United States Department of the Interior

3480
UT (923)
SL-062648

Re: Portal Stoppings/Dewater System Correction, North Crandall Canyon Mine

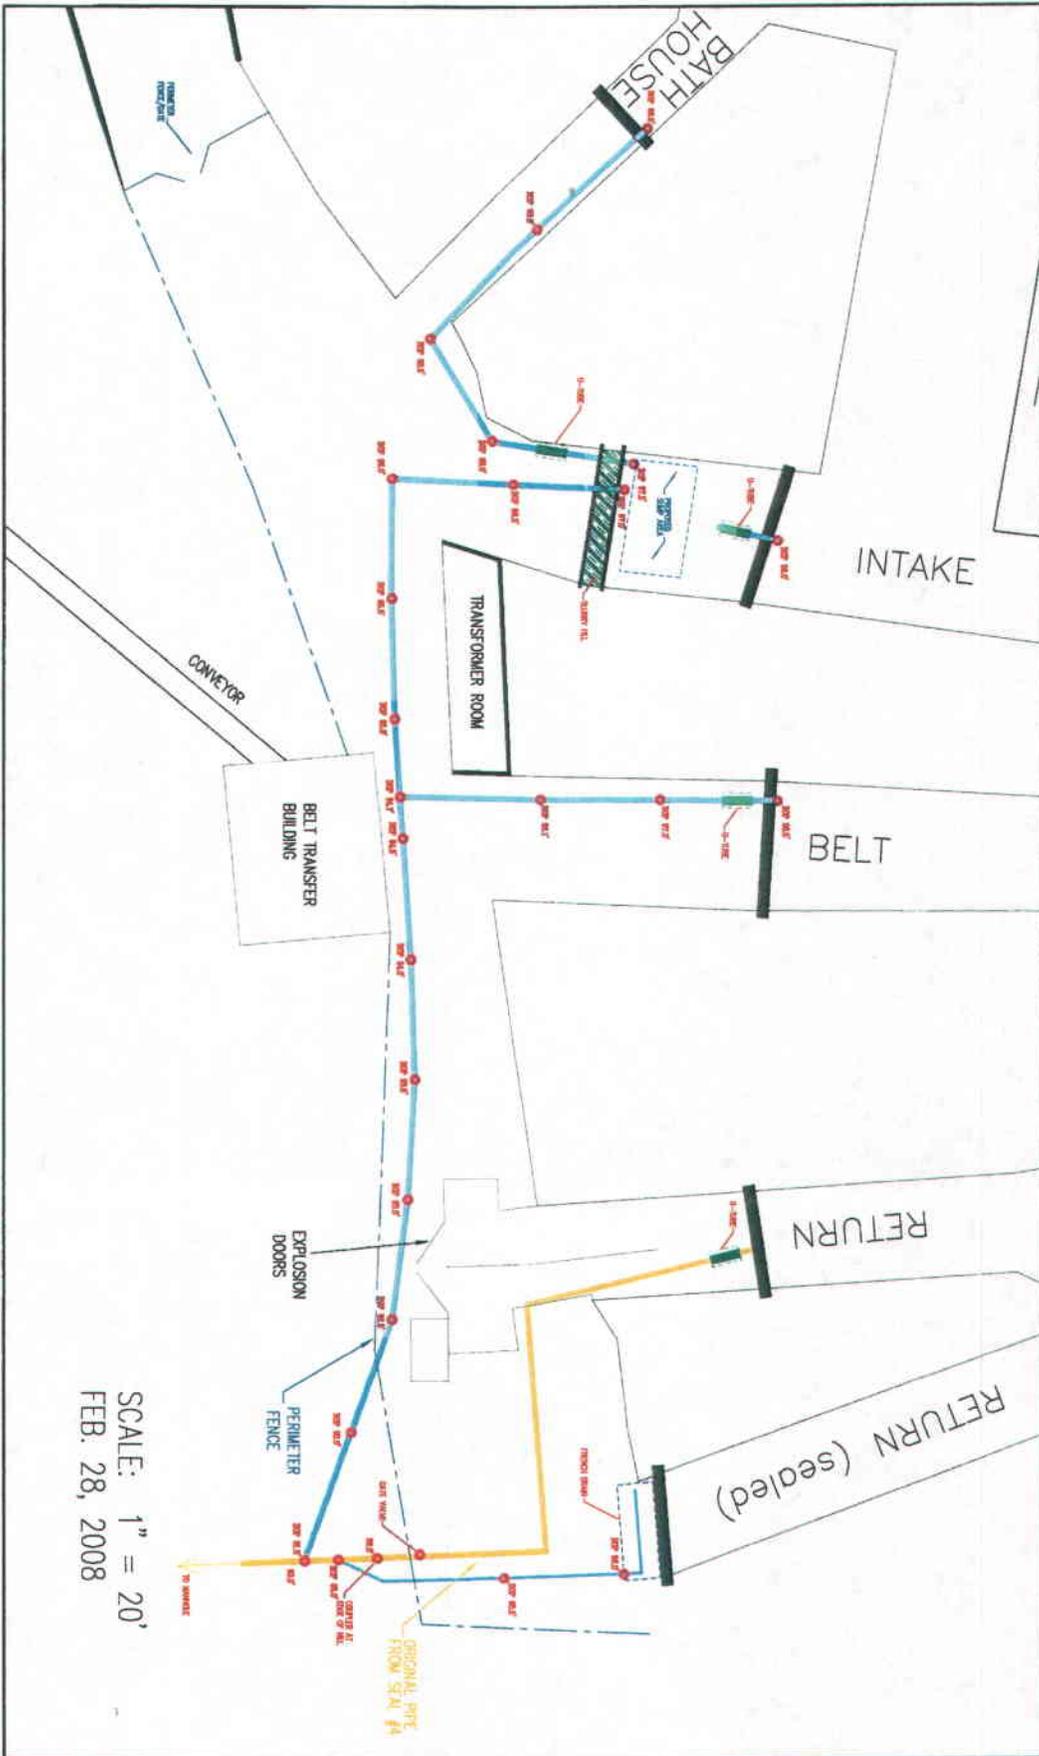
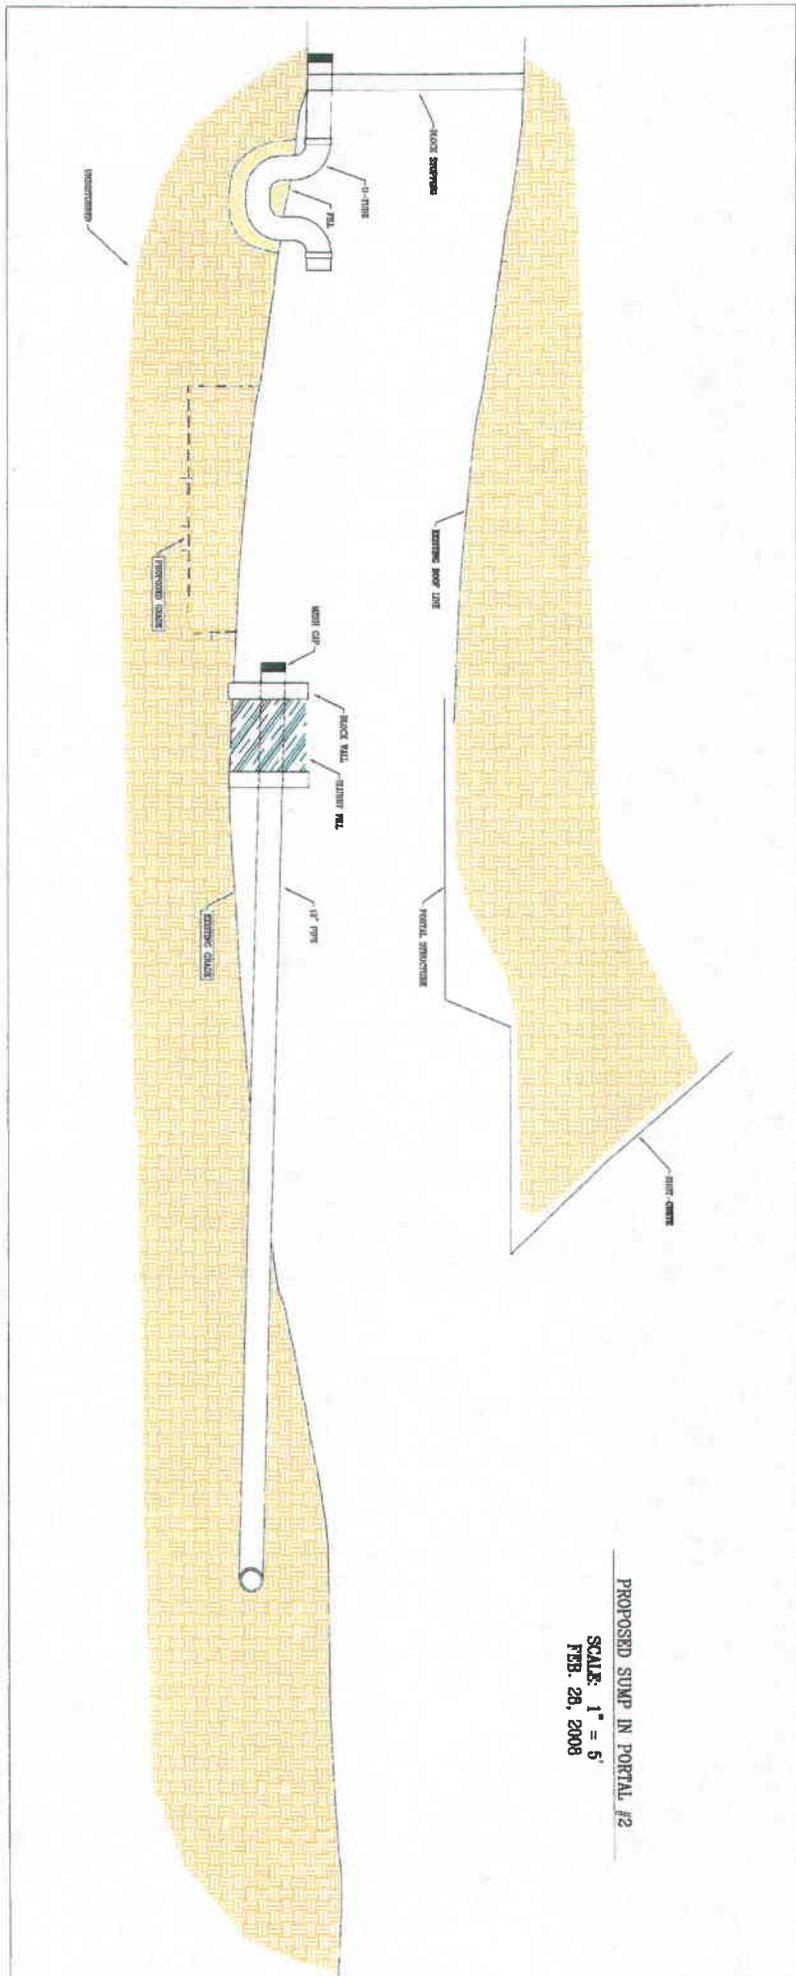
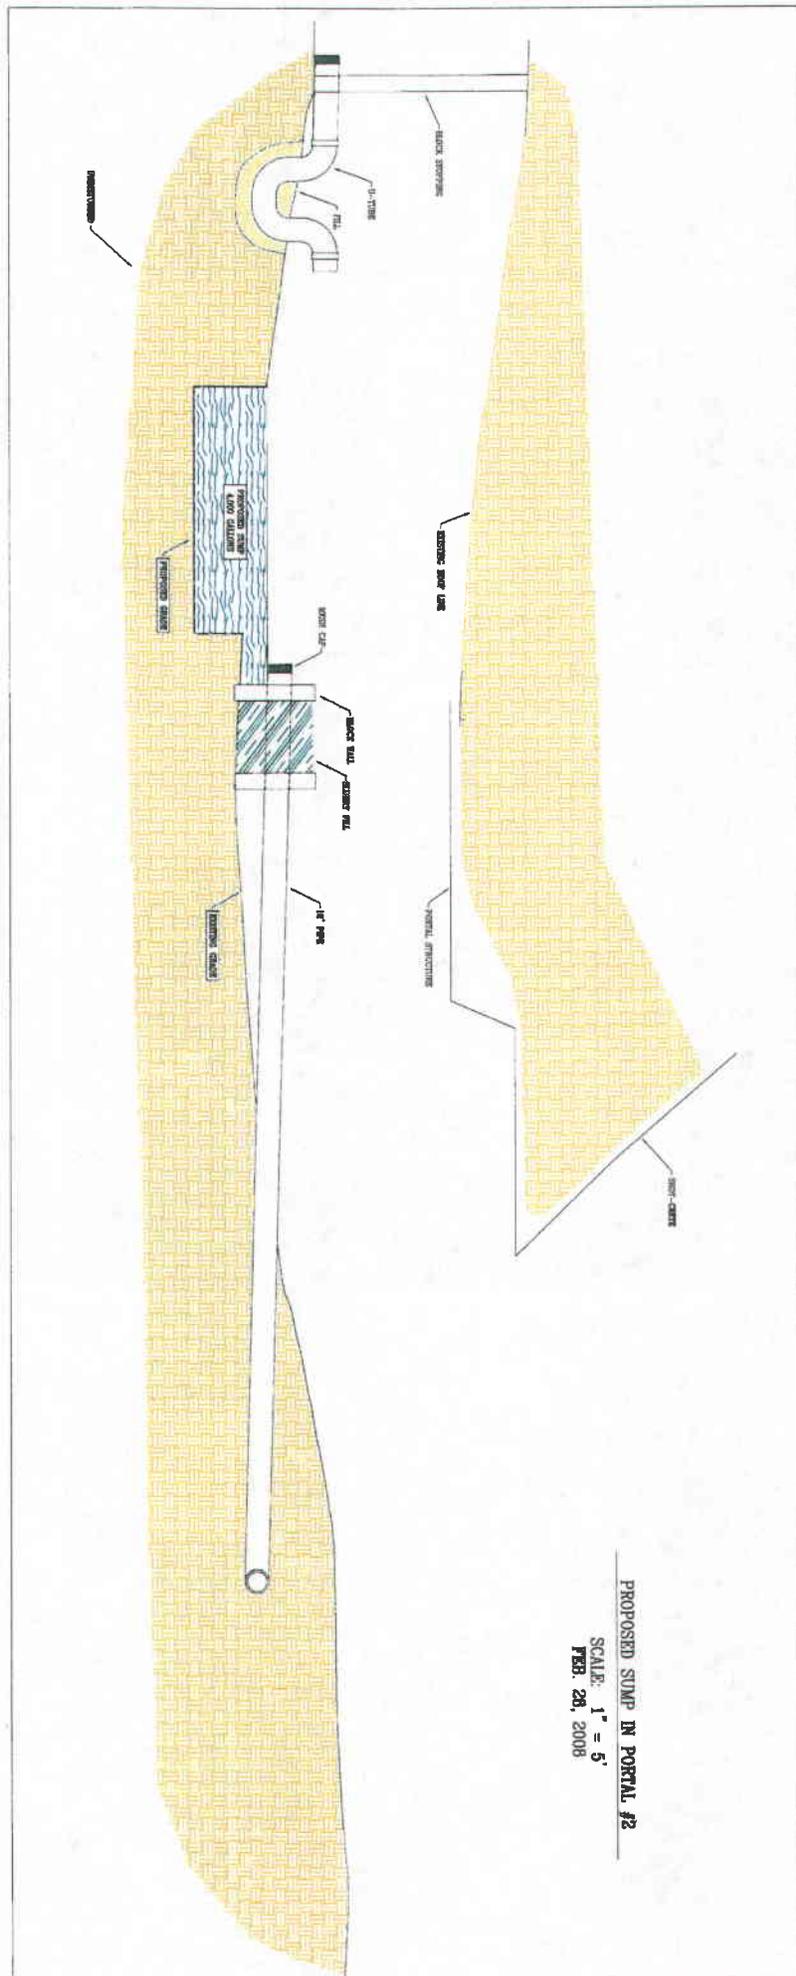
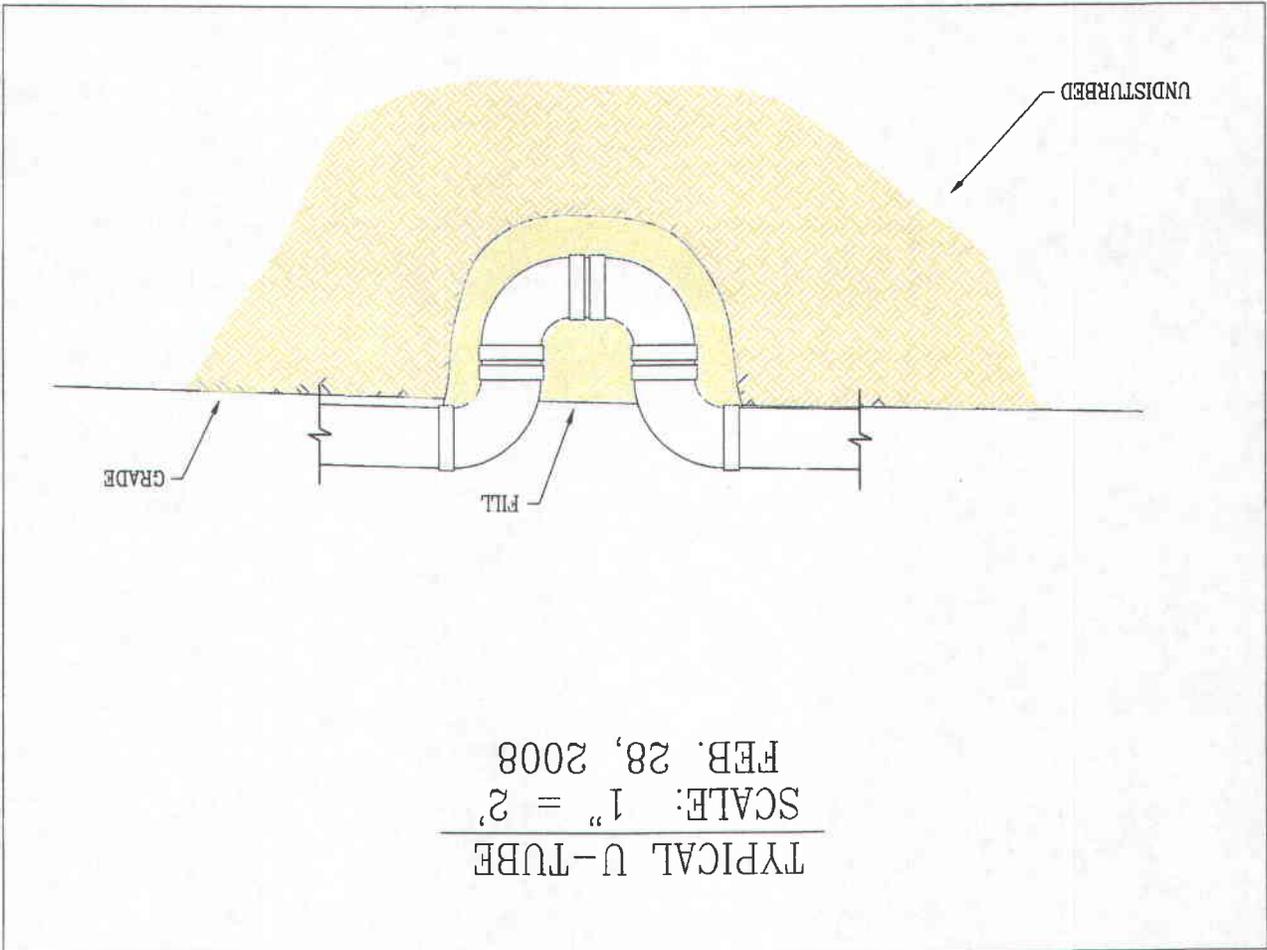
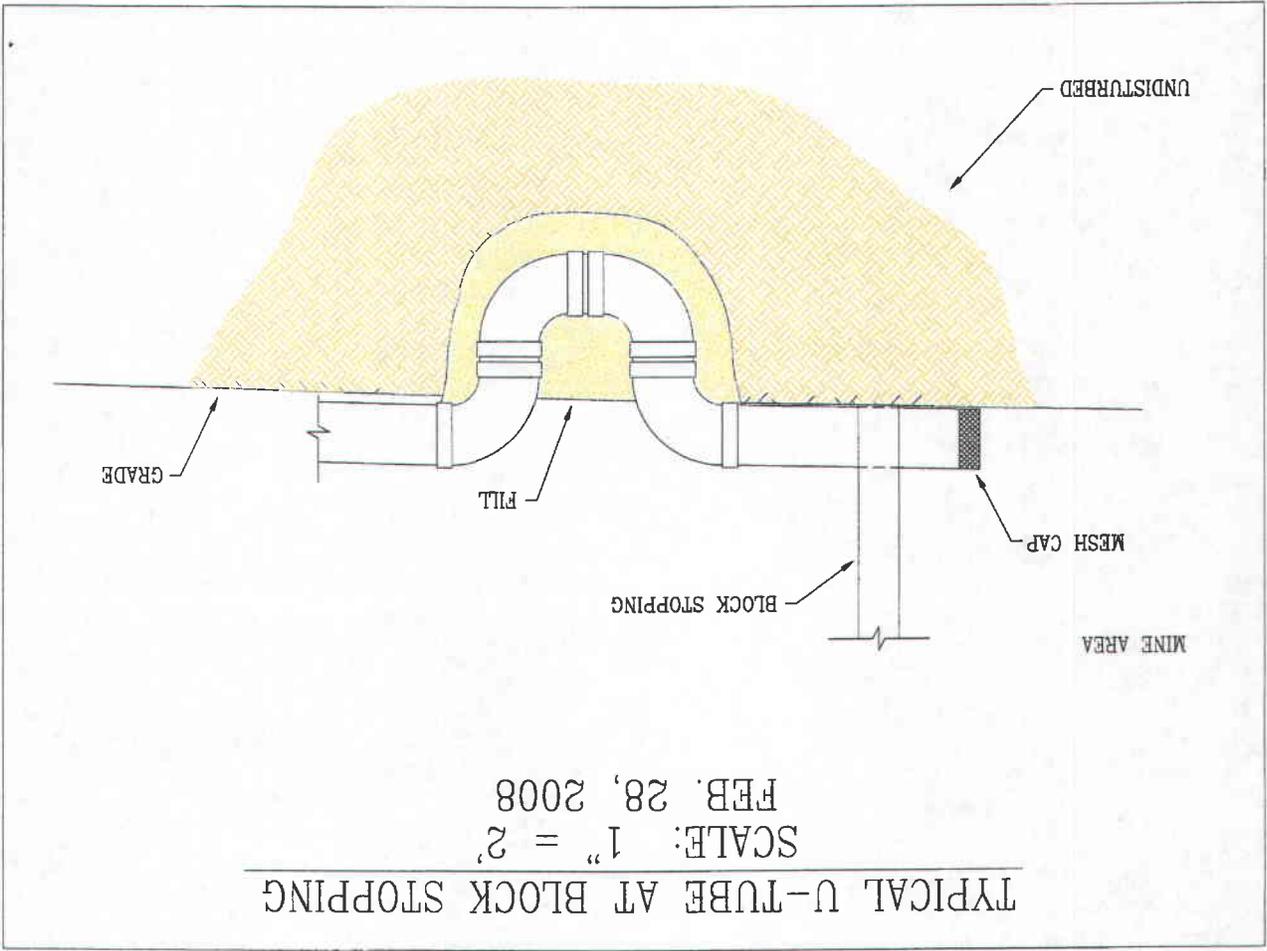
1. The repair or second block wall (in portals 1 through 4, left to right) will be keyed or tied into the rib, roof, and floor as well as to the existing (1st) block wall.
2. The same block walls shall have sampling tubes installed for air sampling the mine atmosphere inby the seals.
3. The slurry filled block wall planned for the intake portal sump needs further detail with dimensions in the design plan.

In acceptance of these conditions, UEI shall revise the design drawings showing the above items on the plan and submit these revisions within 5 days of receipt of this letter. Upon verification of the complete and proper installation of the system, UEI North Crandall Mine will be in compliance with the mine plan on this issue. However, this is not an approval for mine sealing under BLM regulations.
